G.O., No. 2434 W., 20th September 1898.

Estimates, aggregating Rs. 11,660, for certain works connected with the —, sanctioned, with remarks.

Note by the Chief Engineer, Public Works Department.

NOTE BY TECHNICAL SECTION.

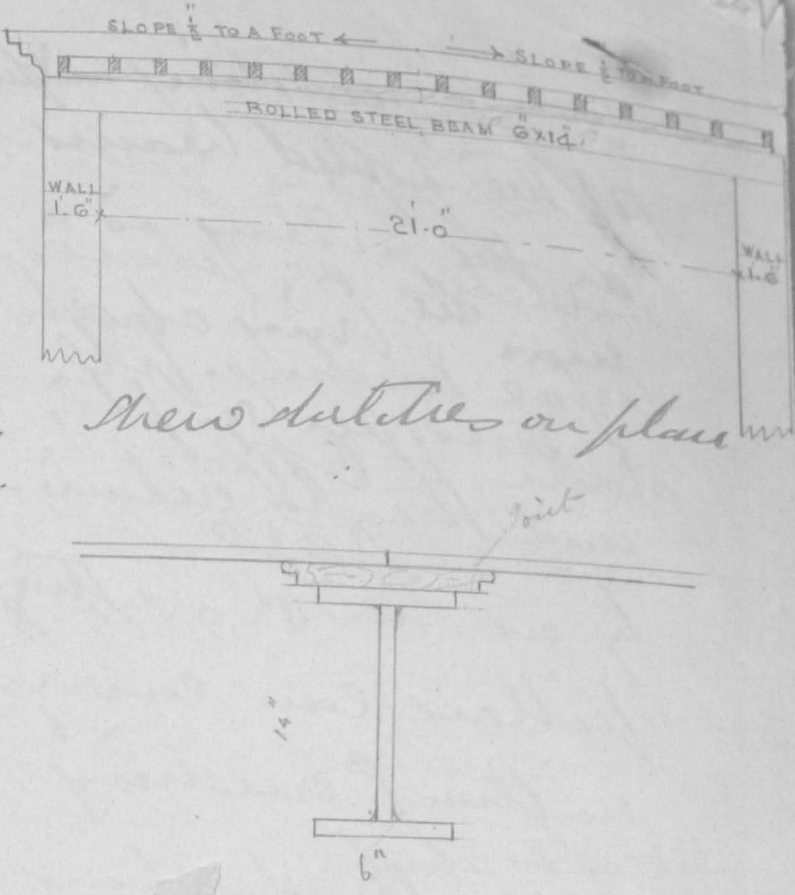
3. The terrace will be made up in the usual manner 9 inches thick, but the thickness at center has been increased to 12 inches to provide a 2 to 4 tons slope to enable the rain water to pass off quickly.

It is submitted that this is not the proper way to effect this. The slope should

piece in a long stick of wood attached to the upper flange of girder as shown in sketch per margin, the joints laid on this & the tinning finished in the usual manner 9" thick. Estimate has been altered, in pencil, accordingly. The Executive Engineer reports that the door is in good order & requires no strengthening or any additional locking arrangements, but provision is made for providing all the windows in the bath with iron bars and new frames.

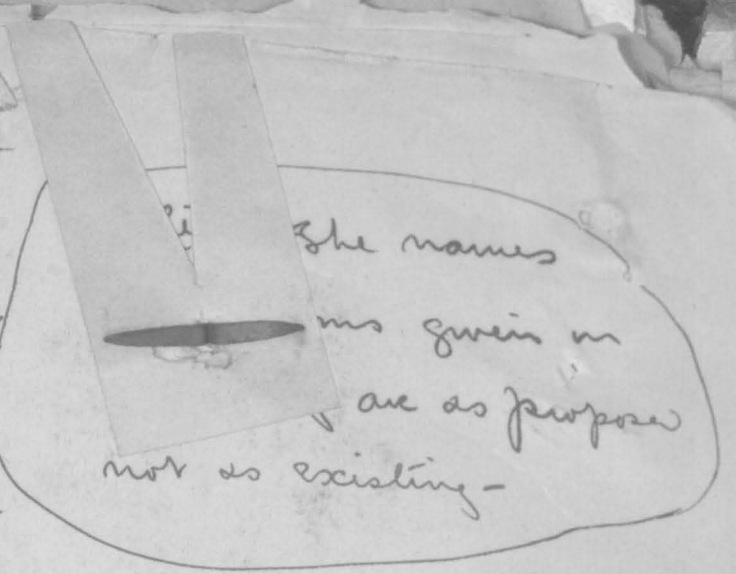
W. The first part of this est. i.e. extending the strong room, is correct but there are several points in the conversion of the swimming bath which require consideration

(a) There is nothing to show that the existing pillars are strong enough to carry a terrace roof or that they have been examined & found safe and sound whether they

(b) steel girders should be substituted for wooden beams in the terrace roof

(c) The terrace roof - as drawn - is $1\frac{1}{2}$ ' thick at the centre but no details of how the terrace is going to be done are given
